1 BACKGROUND

In December 2017, Bengalla Mining Company (BMC) lodged MOD4 under Section 96(2) of the *Environmental Planning & Assessment Act 1979* (EPA Act) to Development Consent SSD 5170. MOD4 was accompanied by a Statement of Environmental Effects (SEE) which generally seeks approval for:

Section 2 of this letter report provides suggested changes to Tables 1 to 3 of SSD 5170 utilising the results of TAS, 2018 (additions are shown in red and deletions in ~~striketrough~~). **Section 3** includes a justification for the suggested changes, whilst **Appendix A** lists references.

Figure 1
Revised Air Quality Contours (Internal)

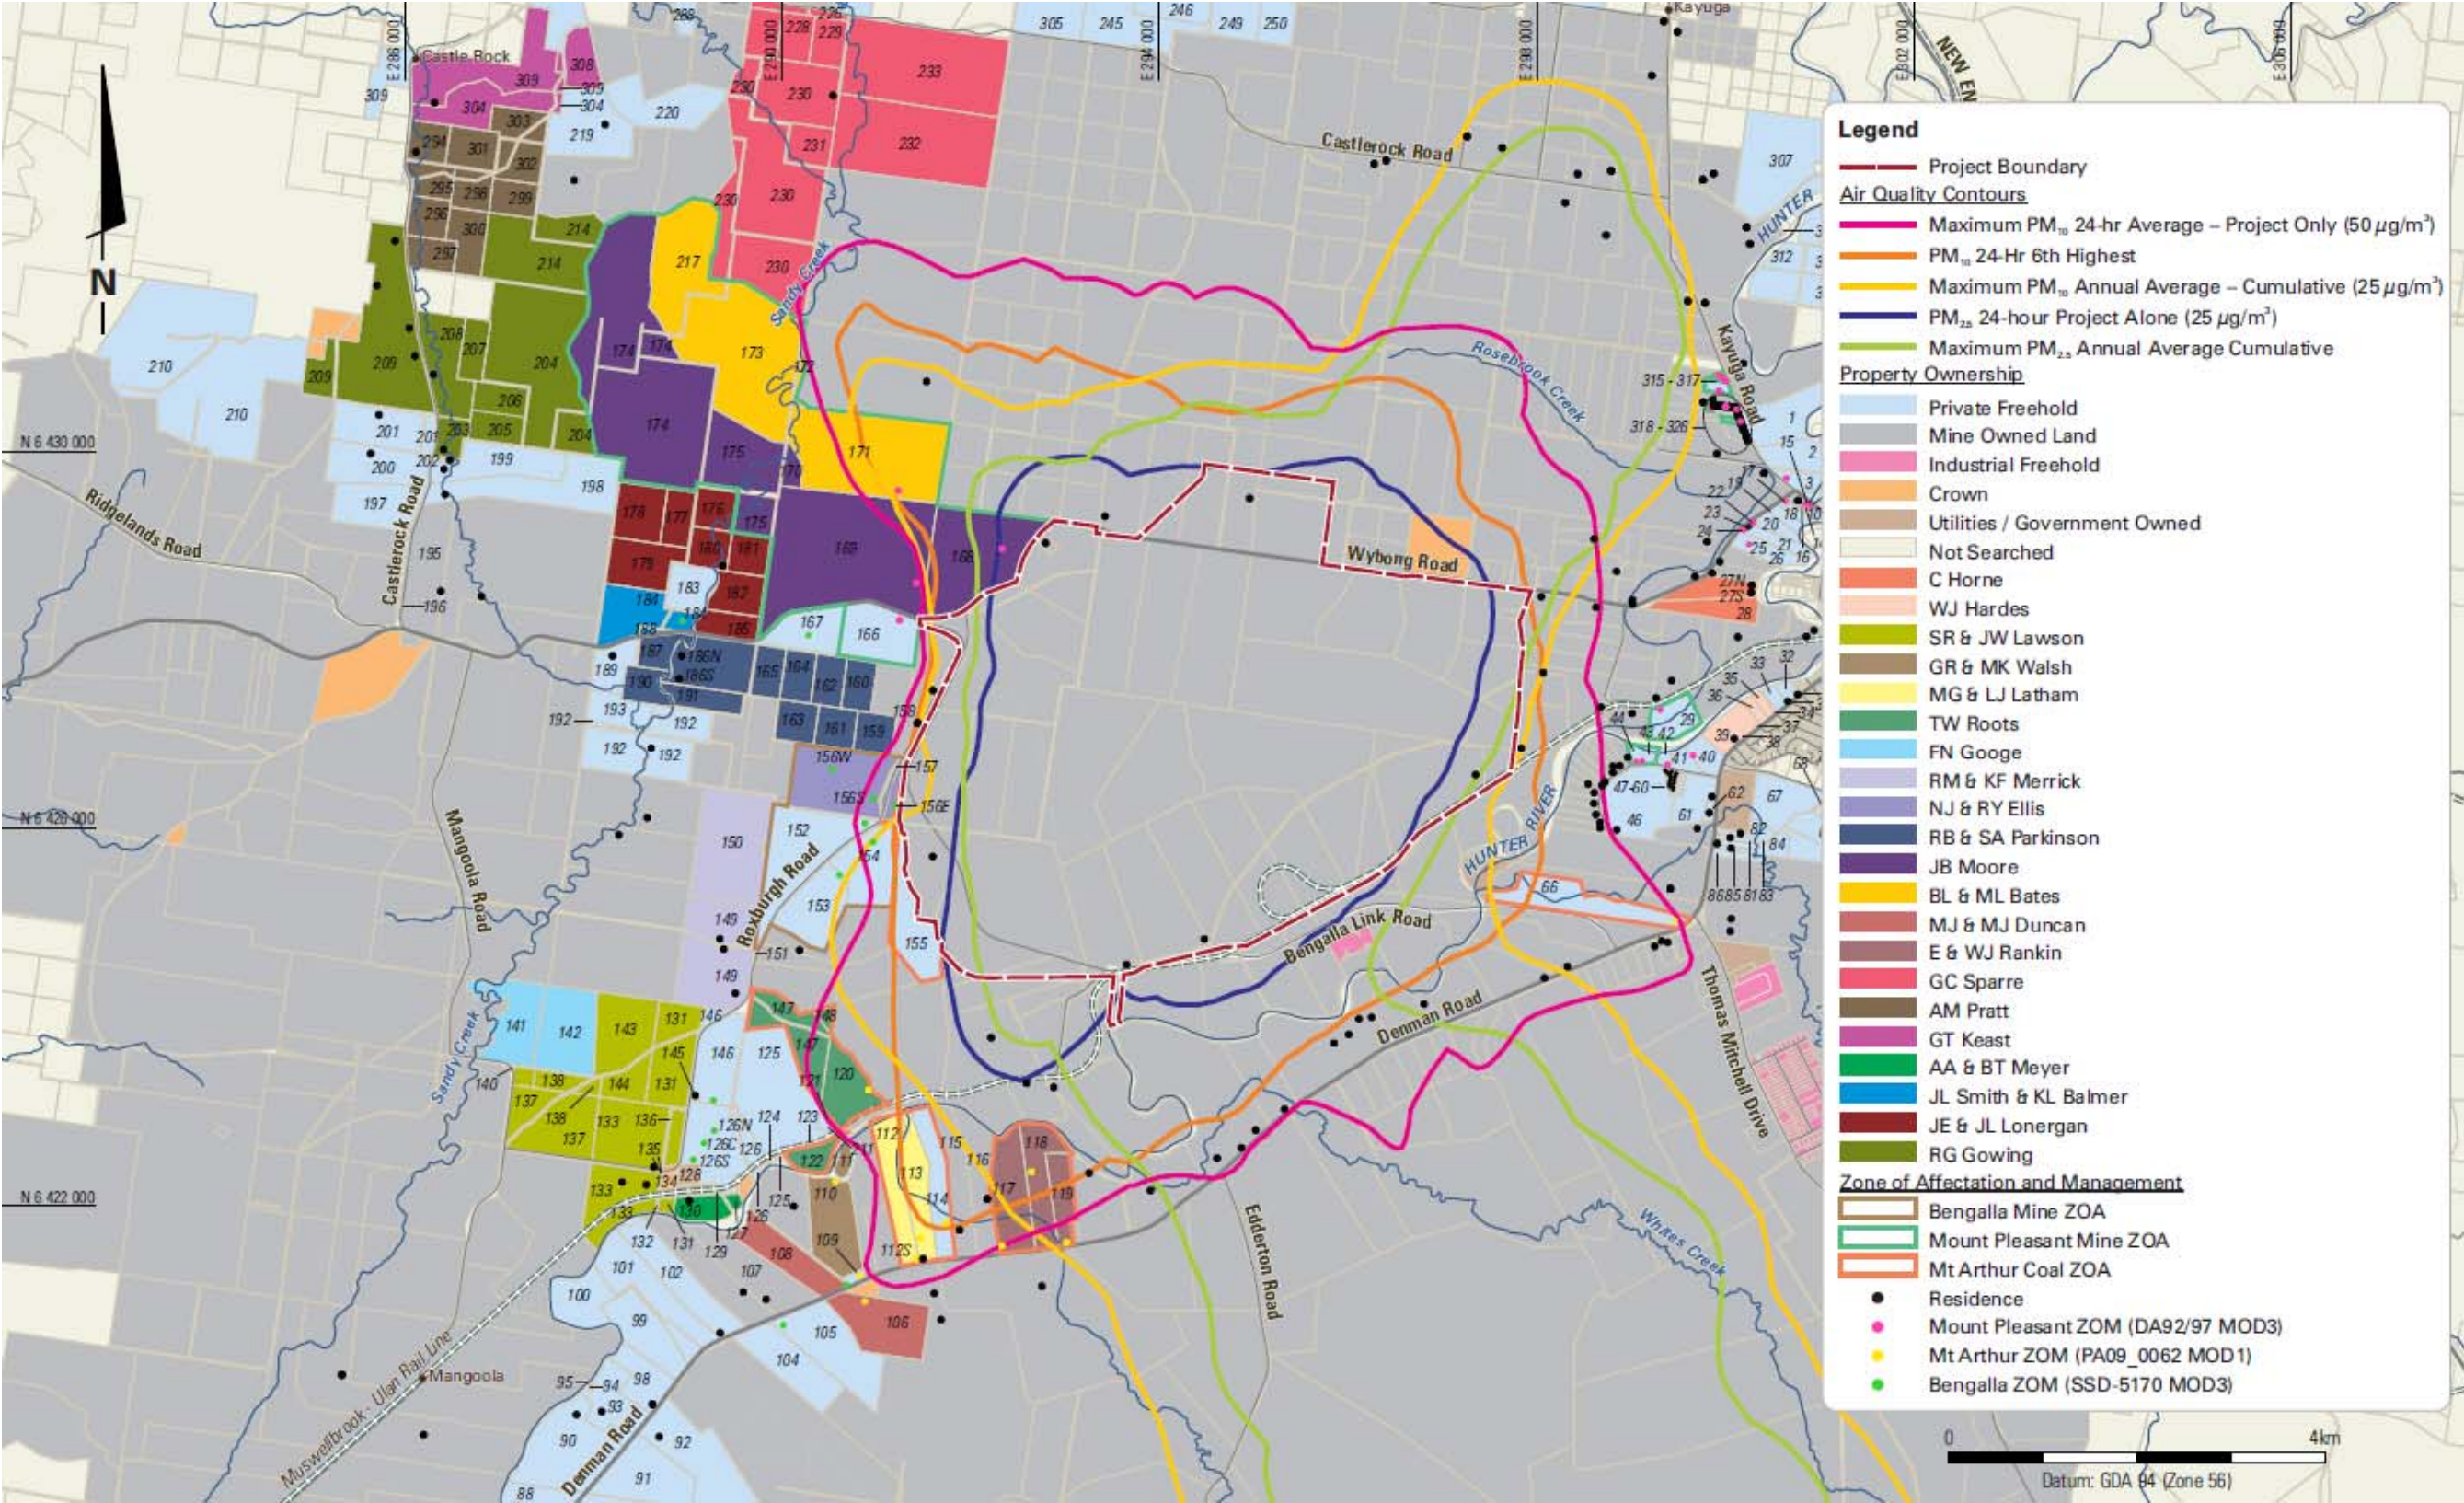
Figure 1 shows key air quality prediction contours from (TAS, 2018) for key air quality parameters (PM₁₀ and PM_{2.5}). It indicates where receivers or blocks of land occur within an existing Zone of Acquisition (ZOA) or Zone of Management (ZOM) for each of Mt Pleasant Mine (MTP), Mt Arthur Coal (MAC) or BMC, as well as indicating contiguous blocks of private property held in single landownership.

As can be seen from **Figure 1**, the greatest air quality impacts are derived from:

- Cumulative PM₁₀ 24 hr project alone (or “incremental”) shown in magenta (ZOM);
- PM₁₀ 24 hr project alone 6th highest (ZOM) shown in orange; or
- PM₁₀ Annual Average Cumulative (or “total impact”) shown in yellow (ZOA).
